P02	19/05/23	Response to RFI	
P01	29/04/22	Issued for Planning	
Revision Number	Date	Drawn	Details of Issue / Revision
Issues & Revisions

Project Details:
Dalgise
Monkstown

Drawing Title:
Proposed Elevations + Sections - Block A

MKS-RAU-A-ZZ-DR-AR-200	Revision
	P02

BLOCK A Elevations/Sections

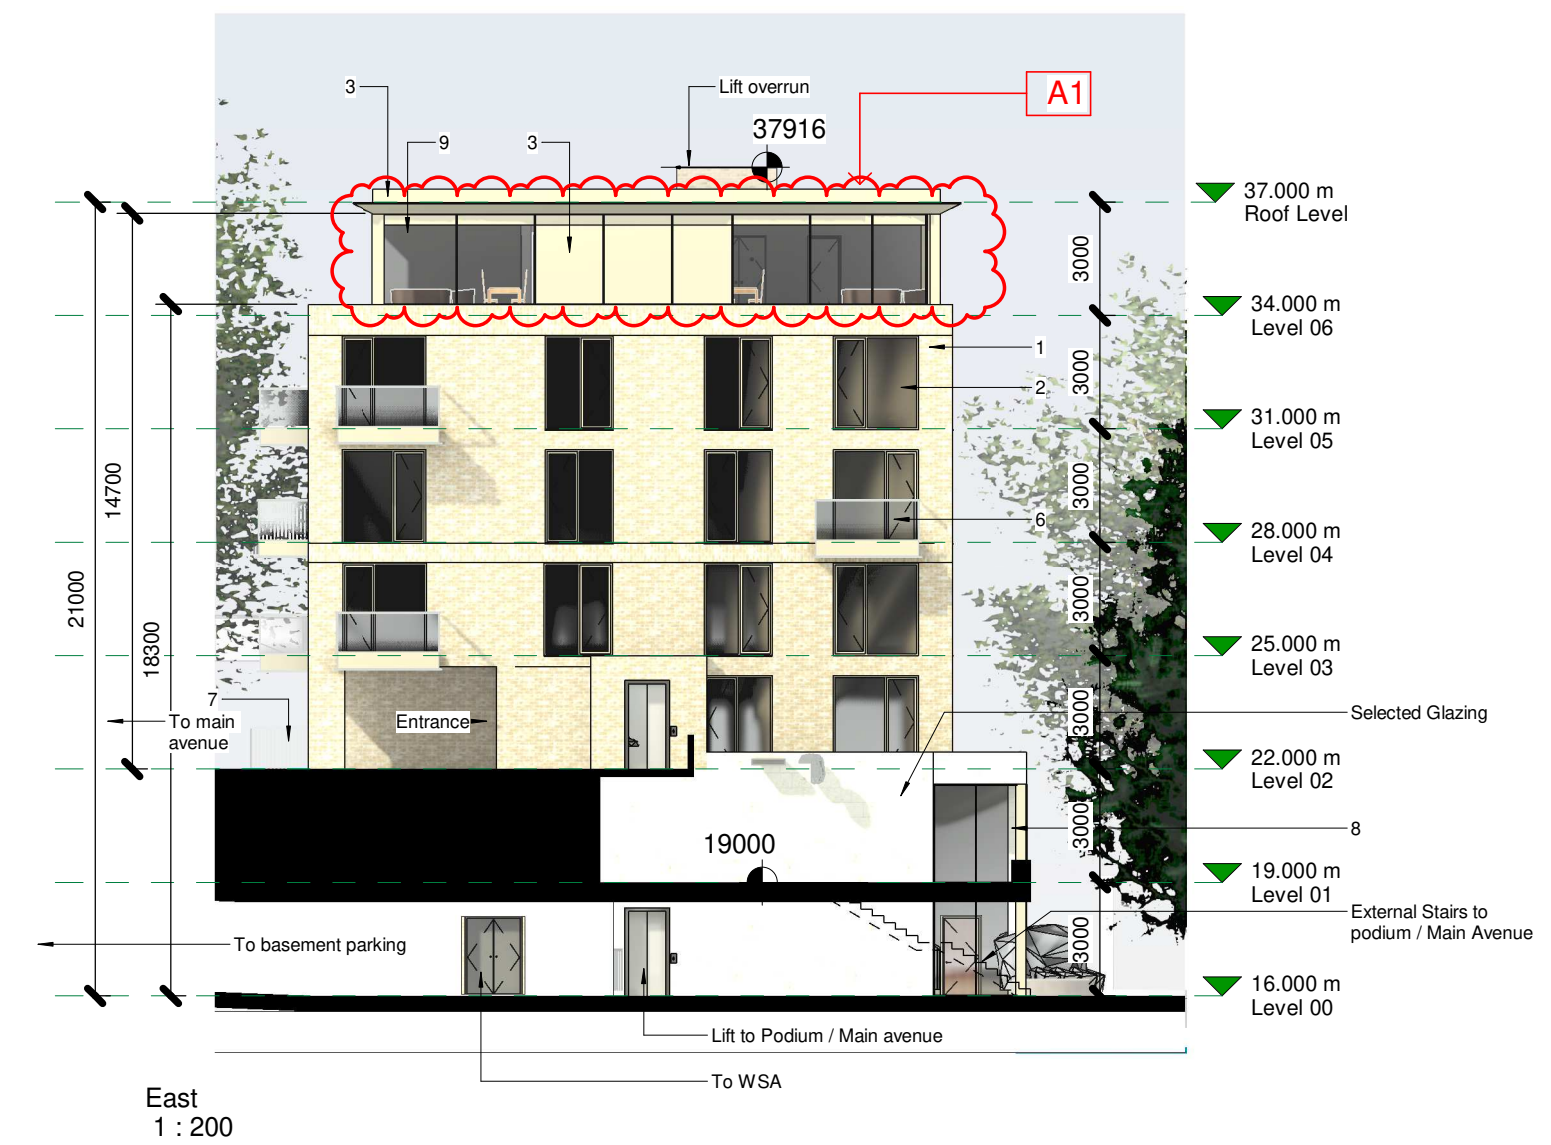
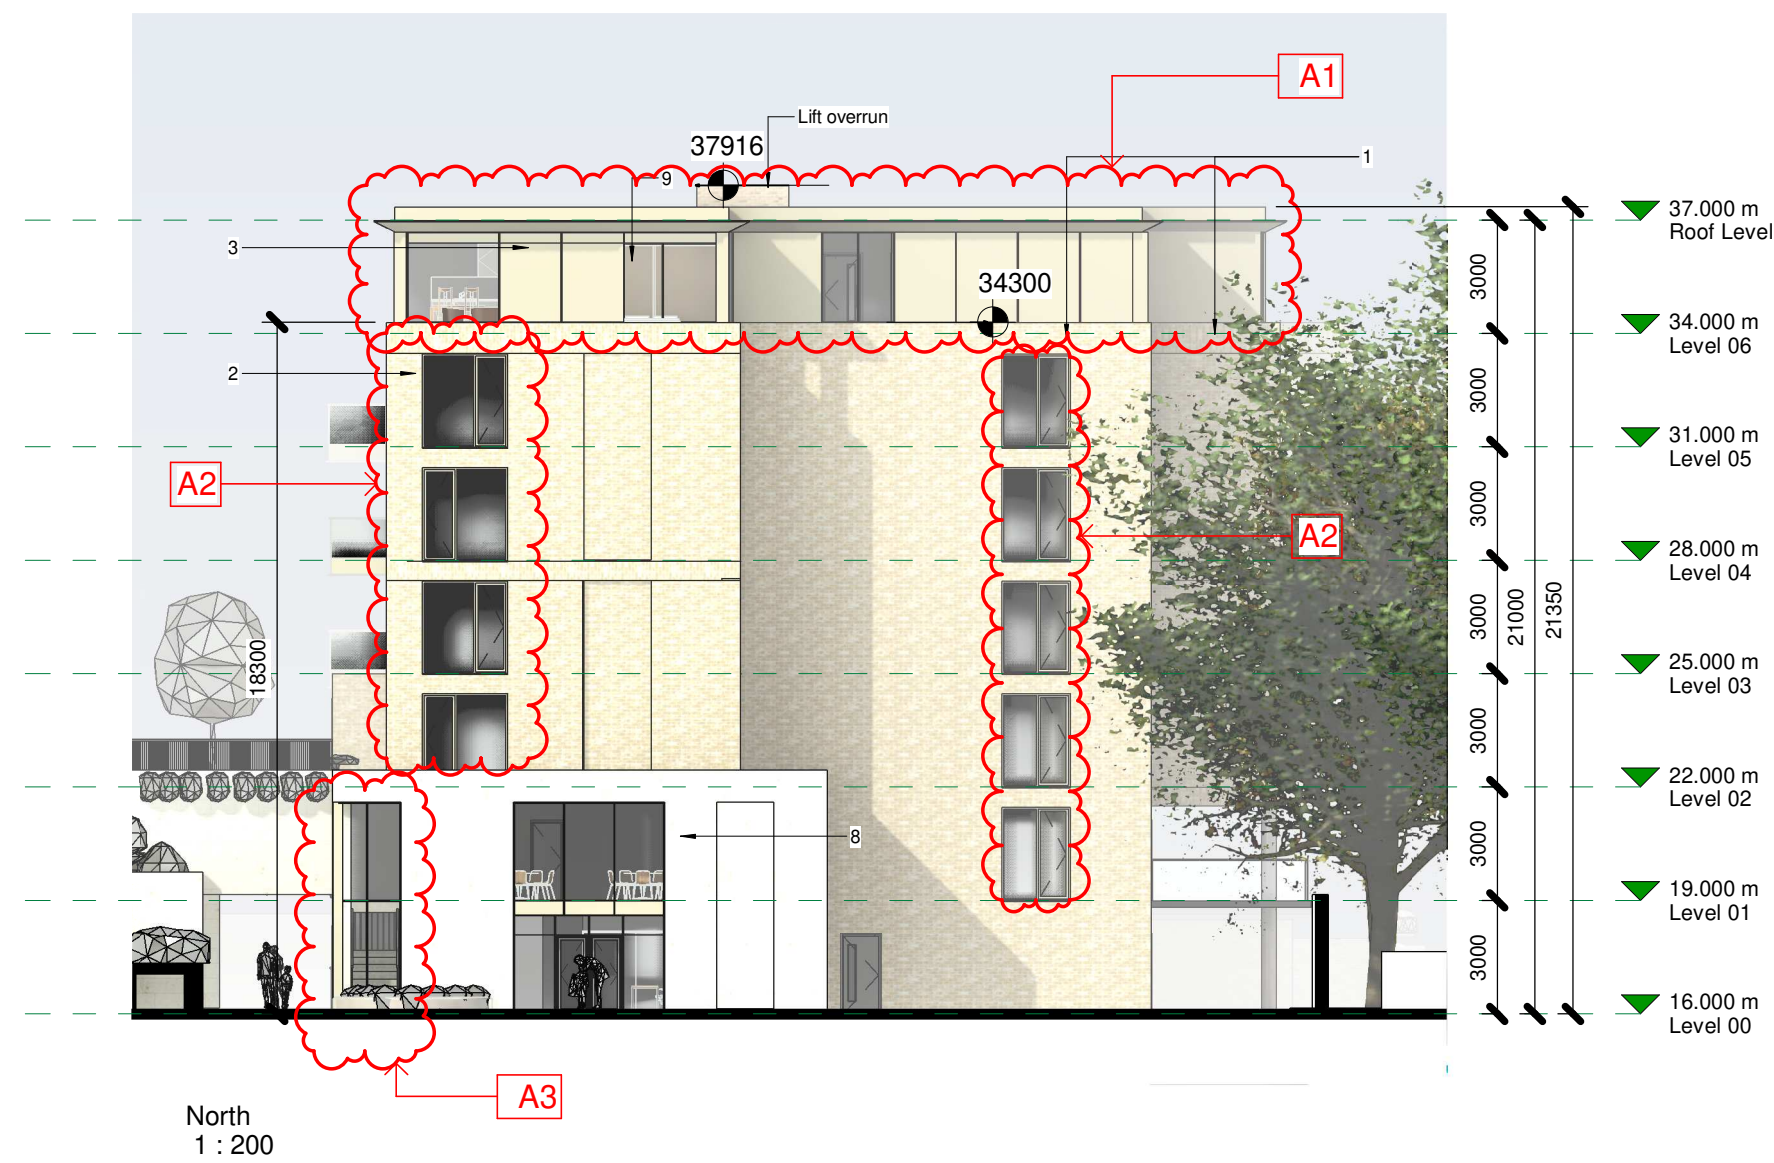
- REVISIONS**
- A1. Tonal Change at Penthouse level.
 - A2. Double height windows changed to single height.
 - A3. Minor alterations to creche layout / elevations.

- S2. Re-alignment of the Basement Car Park Entrance. The Entrance is now located underneath Block B.
